Venice Neighborhood Council

Land Use & Planning Committee (LUPC) STAFF REPORT

City Case No: DIR-2025-2956-CDP-SPPC-MEL

Address of Project: 748-752 Flower Ave

VIII. Renderings of proposed project:

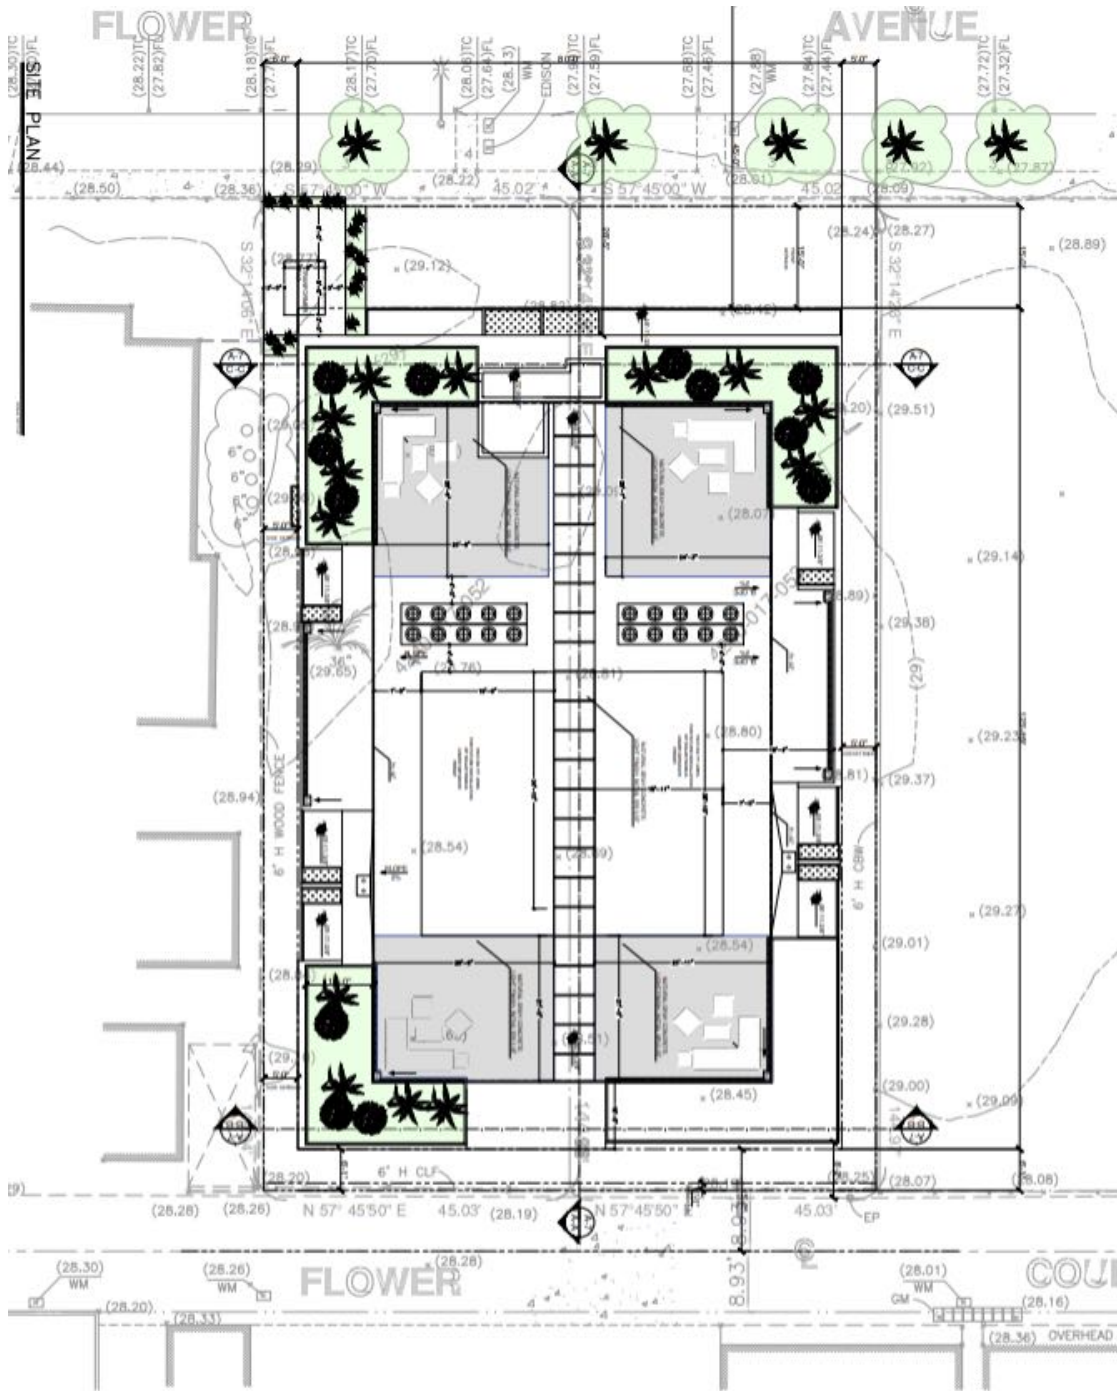
The architectural design of the building now reflects siding and colors which can be found within the neighborhood on Flower Avenue and reflect an understanding of the architecture within Venice. The building is large in comparison with the rest of the buildings in the neighborhood, but this can be justified by its elegant simplicity and lack of adornment, as well as a landscaping plan that will soften its visual impact on the surroundings. The original design of the building made sure that all the sides of the building had architectural appeal, and the changes to the color and materials were applied to all the sides of the building. The property directly across the street is a commercial parking lot, so the building's visual impact will be on its adjacent neighbors and the commercial clients of the businesses on Venice.

Extensive changes were made to the look of the building at the request of the Land Use and Planning Committee. The applicant and his team reflected a flexible and receptive approach and were able to land upon siding and colors that satisfied the Committee and the applicant.

- 1) Enhance aesthetic quality and character by referencing neighborhood and community architectural details, including by changing the colors and siding to echo the greens and steel blue of other buildings on the block.
- 2) Install native plantings and trees that support birds and pollinators and allow residents and neighbors more access to nature both on the property and in the parkway, including the planting of 5 oak trees and up to 3 other trees in the parkway.
- 3) Change the landscape plans to remove concrete from the front yard, retaining a minimum path required for fire code.
- 4) Incorporate water capture infrastructure from the roof into storage of some kind to mitigate the lack of stormwater absorption resulting from reduced open soil.
